***IEEE P802.3dg
Downshift/Upshift
Proposal & Draft Text***

Peter Jones, Cisco Systems

September 2025, Minneapolis, MN

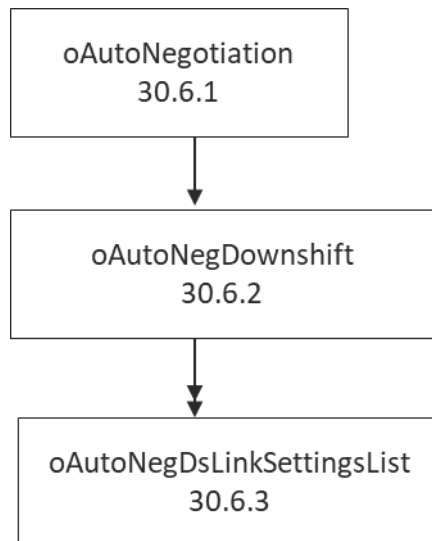
Change Figure 30–3 by adding oAutoNegDownshift and oAutoNegDsLinkSettingsList within oAutoNegotiation as follows:

If implemented, oAutoNegDownshift is contained within oAutoNegotiation. The oAutoNegDownshift managed object class provides the controls necessary to manage the Downshift/Upshift functions of Auto-Negotiation.

If implemented, oAutoNegDsLinkSettingsList is contained within oAutoNegDownshift. The oAutoNegDsLinkSettingsList managed object class provides additional controls necessary to manage the Downshift/Upshift functions of Auto-Negotiation.
